MONITORING YEAR 2 ANNUAL REPORT

HONEY MILL MITIGATION SITE

RE: FINAL: Year 2 Monitoring Report
Honey Mill Mitigation Site, Surry County
Yadkin River CU 03040101
DMS Project ID No. 100083 / DEQ Contract #007619

Wildlands Engineering, Inc. (Wildlands) has reviewed the Division of Mitigation Services (DMS) comments from the Final Year 2 Monitoring Report for the Honey Mill Mitigation Site that were received on January 20, 2023. The report has been updated to reflect those comments. The Final MY2 Report is included. DMS' comments are listed below in **bold**. Wildlands' responses to DMS' comments are noted in *italics*.

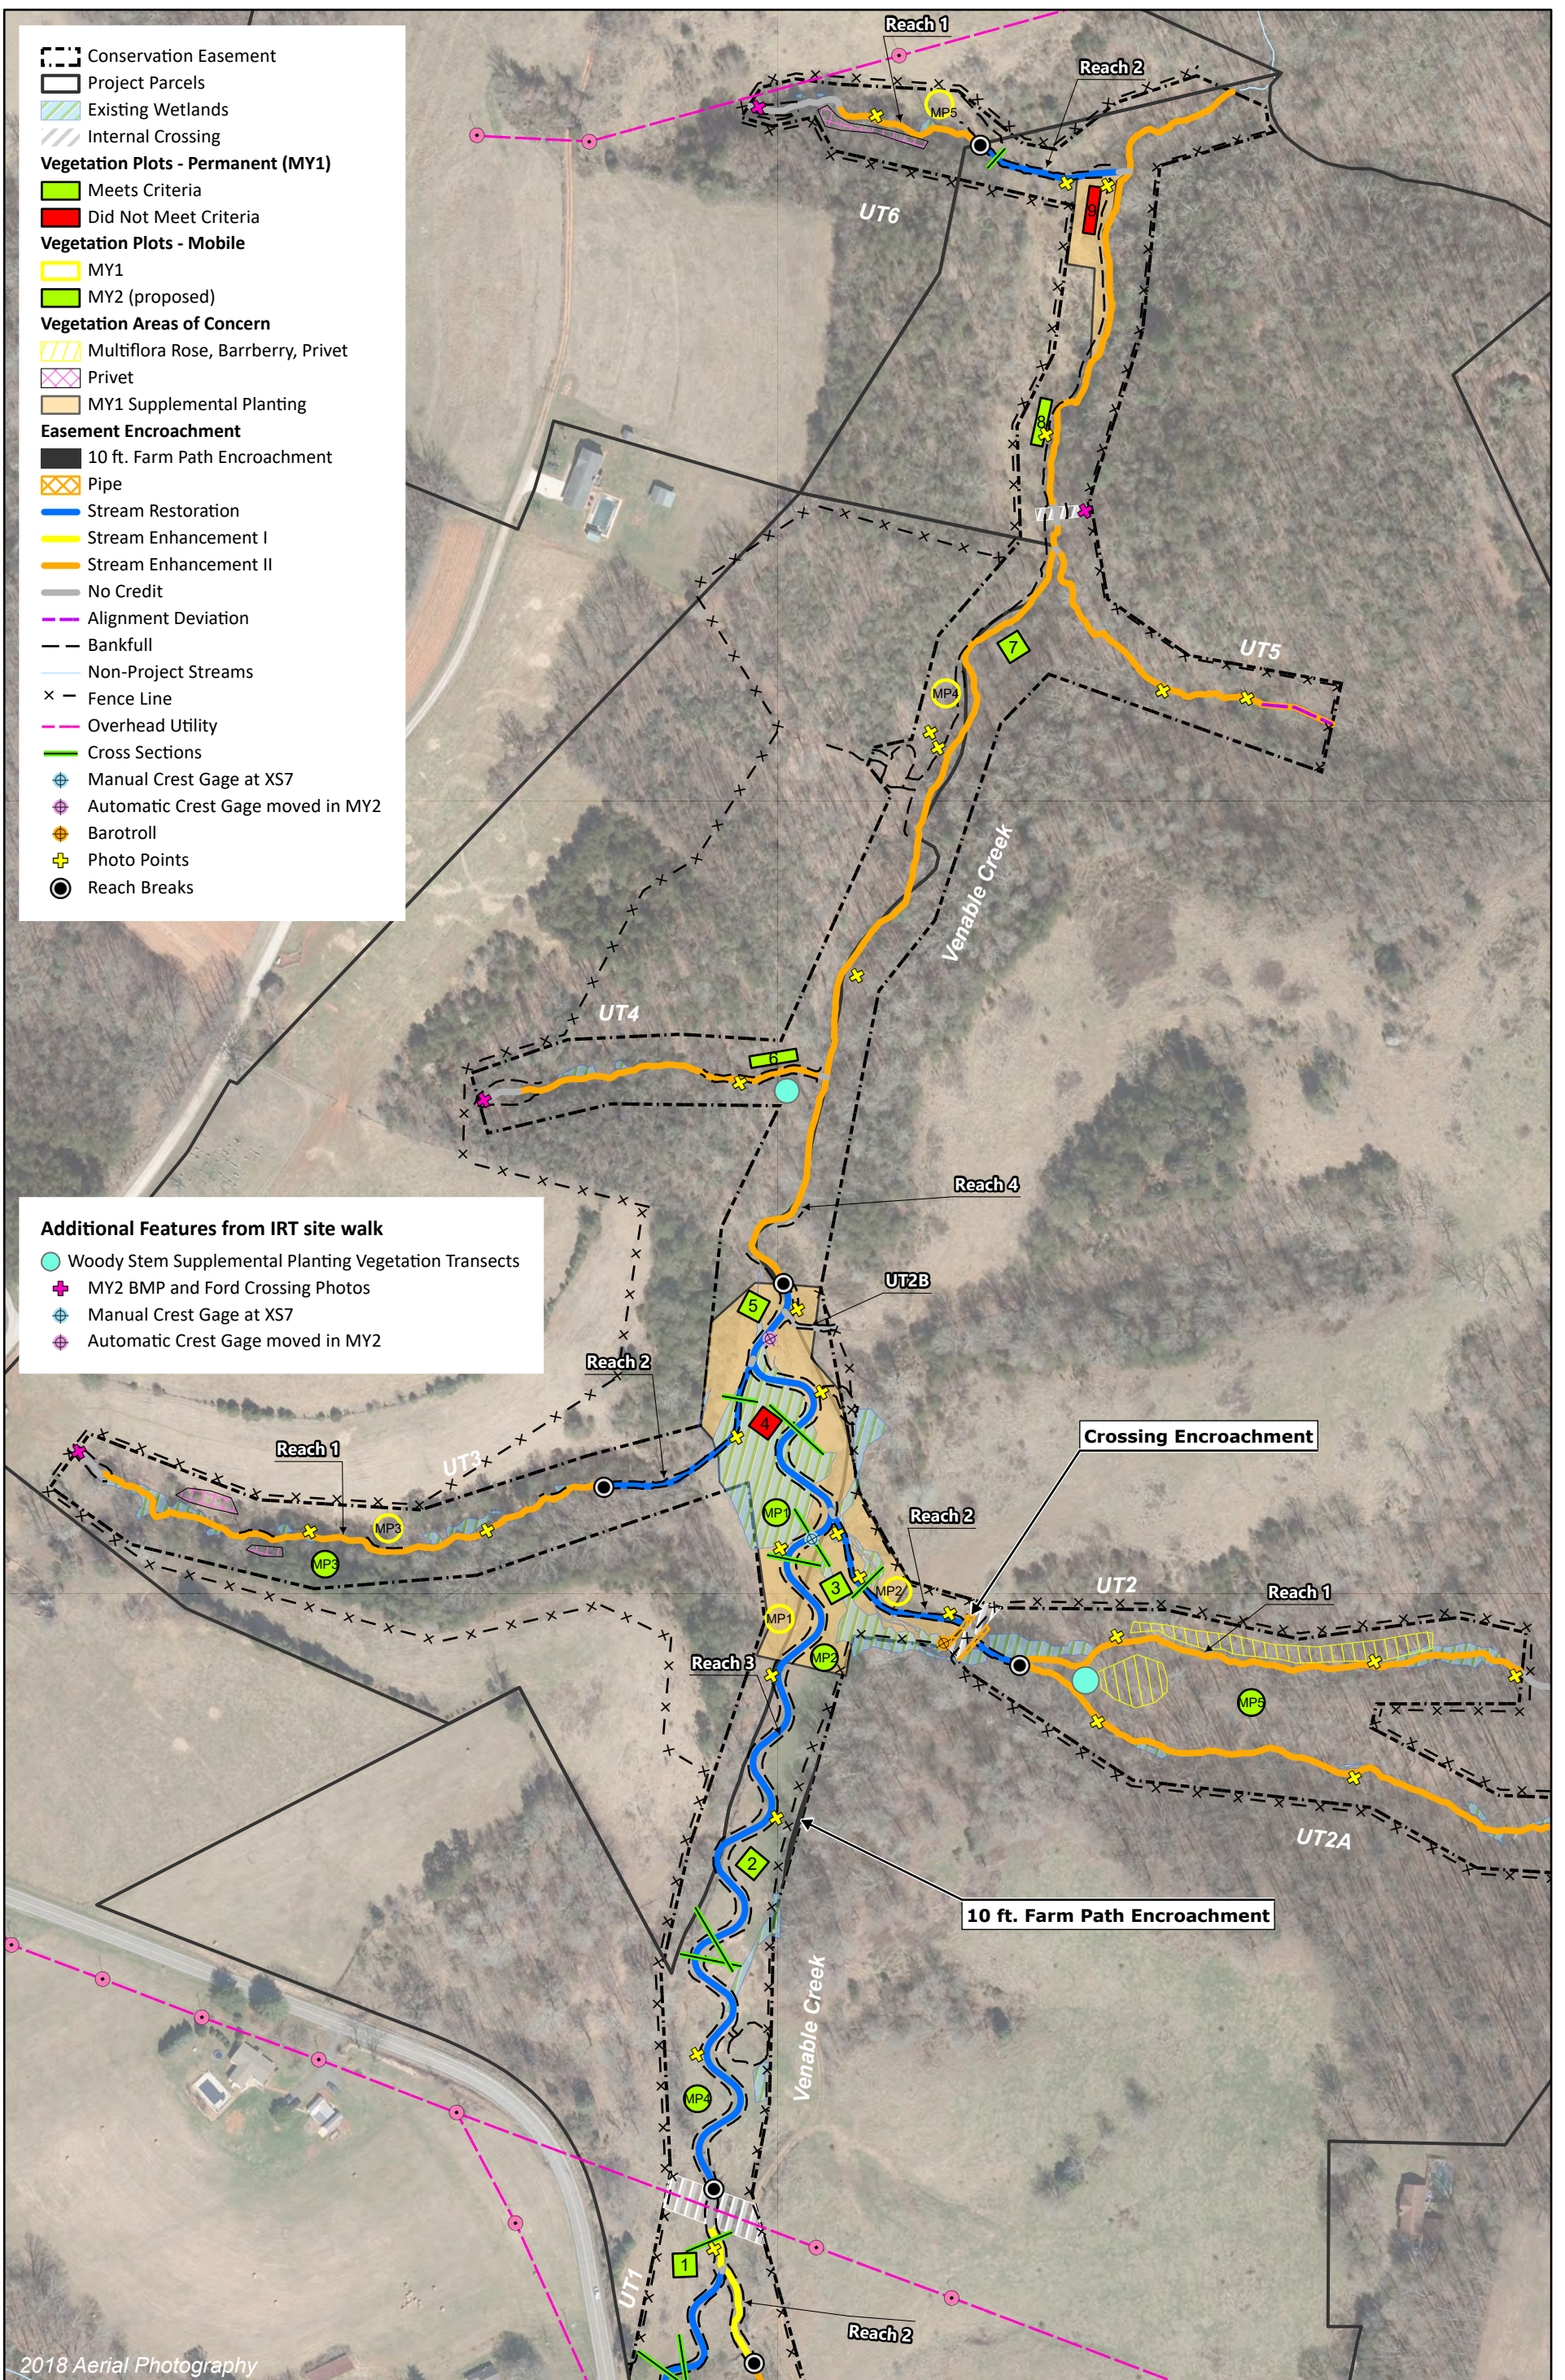
- d) Regarding CG1, which hasn't recorded a bankfull event: Erin remarked that they normally see them installed in pools and asked how often readings were taken. Ella responded every 3 hours. Ella said that a manual gage was added to XS7 near CG1. Kim suggested that CG1 be moved to a different location in the same reach and leave the manual gage at the current location. The addition of a manual gage and relocation of crest gage should be noted in the MY2 report. The new crest gage location is noted in the attached figure.

- n) Kim requested that photo points be added at BMPs. The attached figure shows the additional BMP photo points.
- o) Kim asked that an eye be kept on the spring seep in the right floodplain of Venable Creek.

- p) Erin suggested that matting and live stakes be added to the Venable Creek meander bend just upstream of UT3 confluence.
- q) On UT2, Kim suggested that a transect be added upstream of the culvert crossing in the wooded area to monitoring understory planting. She said that understory planting will not be held to density or height requirements. Erin added that they are open to understory planting suggestions on materials/methods that produce the best results. The monitoring results will be evaluated to assess the viability and monitoring approach for future understory planting plans. The transect locations are shown in the attached figure.
